# Bedroom 1's bathroom · design review F-05 · accept the route (A) or a private bathroom (B)? · Taif / Palm House · A ADOPTED · B NOT ADOPTED: young children's room (owner, V9.0)

**OPTION A ADOPTED by the owner (2 Nov 2026): no private bathroom; the wet areas stay grouped in the two clusters; night lights along the route.** 2 Nov 2026, after the stair flip (option B, F-b) · bedroom 1 is the north-east room over the maid wing, 15.75 m² on axes, 13.9 m² clear, one room without a bath · nothing in the design files changes until the owner decides · all sizes assumed

bedroom 1 · A · 1 m = 0.95 cm · north up · brown dotted = the ground floor below

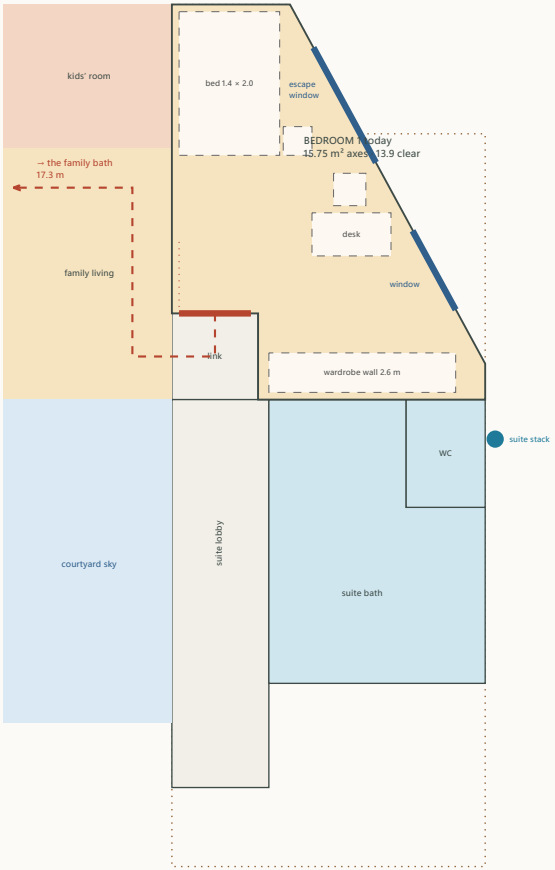
- **The walk, measured after Part 1** (the stair flipped, the family bath enlarged northwards; its door stays at x 4.25, y 9.3–10.3): bedroom 1's door → the family link → the family living, behind the sofa → the gallery's north part, past the stair arrival → the gallery → the bath's door: **17.3 m** (the same as before the flip: the bath grew, its door did not move). Five spaces, two of them lived in (the living, the gallery).

- **Who shares the family bath:** bedroom 1 (17.3 m), bedroom 2 (2.7 m), the kids' room and the family living (a bedroom later); bedroom 3 and the suite have their own. Since F-b it has **two compartments** (a WC by the shaft and the shower + double basin), so two children at once.

- **Comfort:** a child or a guest in bedroom 1 crosses the **family living** at night and in the morning, in sight of whoever is there; 17 m is the longest bathroom walk in the house (the suite's is 0, bedroom 3's 2.7, bedroom 2's 2.7).

bedroom 1 · B2 · 1 m = 0.95 cm · north up · brown dotted = the ground floor below

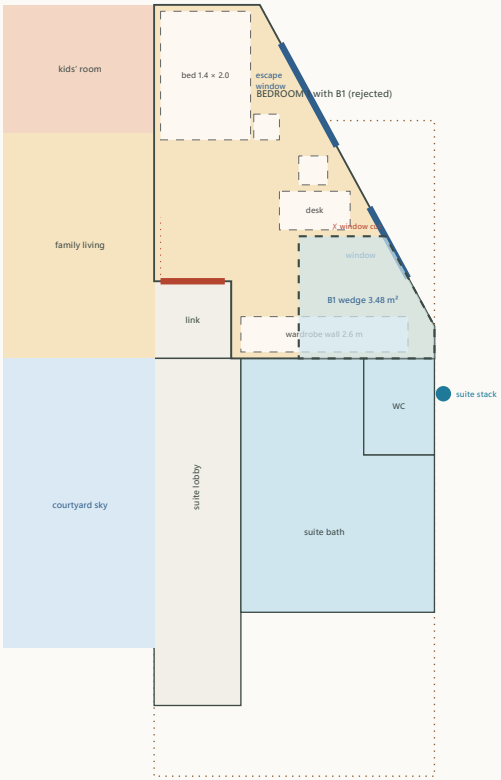
- **B2 (the best, drawn):** a bath along bedroom 1's **south wall**, x 10.6–13.311, y 5.0–6.5, its east end following the cut wall: **3.79 m² on axes, 2.49 × 1.3 clear less the slant ≈ 3.0 m²**: a walk-in shower 0.9 × 1.2 at the east end (its corner 0.02 m west of the cut wall), the WC in the middle facing north, the basin on the west wall, a **sliding 1.0 m door** from the room (no swing), a **small window on the cut wall** (y 5.35–5.85, sill +1.60, obscured). It is **next to the master suite's wet stack**: the pipes run 2.5 m east in the bath's own floor zone to the suite's stack outside the east wall (y 7.05), **over the GF maid room only** (the kitchen and its hood zone start at y 7.0; nothing over the master bedroom).

- **Bedroom 1 with B2: 11.96 m² on axes, ≈ 10.3 m² clear** (was 15.75 / 13.9): the bed 1.4 × 2.0 stays on the west wall with its bedside table, the desk and chair under the escape window, the wardrobe wall (2.6 m) becomes **two wardrobes, 1.3 m on the bath's wall and 0.9 m on the west wall** (2.2 m in all); the door's swing stays clear; the **escape window stays the room's** (the fire study unchanged); the second window (y 4.15–5.25) lights the desk. Still a full bedroom (a 1.4 bed, a desk, 2.2 m of wardrobe), no longer a two-bed room.

- **Drain:** the shower, the WC and the basin to one branch running east along the bath's south side to the **suite's stack** outside the east wall (y 7.05), 2.5 m; the branch crosses the room's south wall line at x 13.311 and turns south outside the wall for 0.6 m (or a second stack beside the suite's; the MEP engineer). **Over the GF maid room only**: not over the kitchen (y ≥ 7.0), its hood zone (the east wall y 10.2–11.2) or the master bedroom (x 8.95–13.311, y 11.9–19.25).

- **Structure (`studies/structure.typ`):** the maid wing's first-floor bay is a **solid 0.20 slab** spanning east–west 4.36 m to the cut wall; a 0.15 depressed zone cannot be cut from 0.20. Two ways, the engineer's choice: **(i)** cast the bay 0.35 thick under the bath with its top depressed 0.15 (as the suite bath, X10), or **(ii)** keep the slab and run the pipes **below** it in the maid room's ceiling void (the maid room gets a gypsum ceiling anyway; 3.1 m clear left) with a wall-hung WC and a shower tray raised ≈ 0.10. The bath's walls are light partitions on the slab (no beam; B6 at y 6.5 is the room's south wall beam, untouched).

- **Windows:** the bath's small window on the cut wall faces the lane side (obscured glass, a vent); the room keeps both its windows. **Ventilation:** the window plus an extract fan to the roof riser is not available here: an extract through the cut wall (a small louvre) or a duct in the ceiling void to the east wall.

1. **A** (accept the 17.3 m route, no bath) or **B2** (the private bath along the south wall, ≈ 3.0 m² clear, the room 10.3 m² clear)? If B2: the slab detail is the engineer's; the wardrobe split (1.3 + 0.9 m) accepted?

bedroom 1 · B1 · 1 m = 0.95 cm · north up · brown dotted = the ground floor below

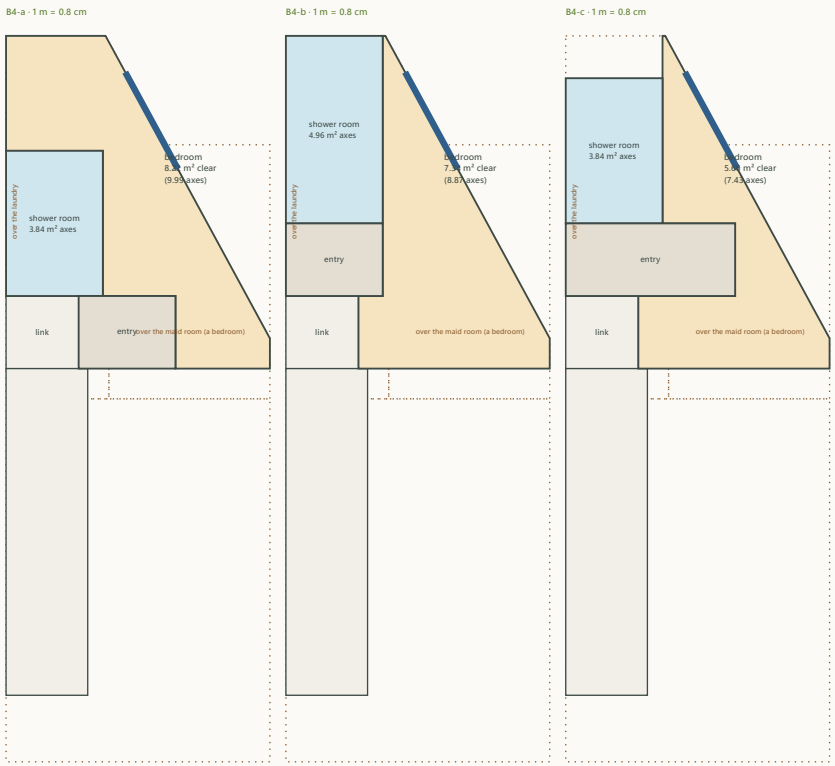
- **B1 (the south-east wedge, dashed on page 2):** x 11.2–13.311 on the cut wall, 3.48 m²: a wedge, its north wall cuts the second window (y 4.15–5.25) and leaves 0.8 m of the wardrobe wall: worse than B2 for the same plumbing. **B3 (the north-east corner):** the north-east corner (x 10.6–12.0, y 1.0–2.9) holds the room's **escape window** and the bed's head wall: a bath there moves the escape window and the bed; rejected without drawing.
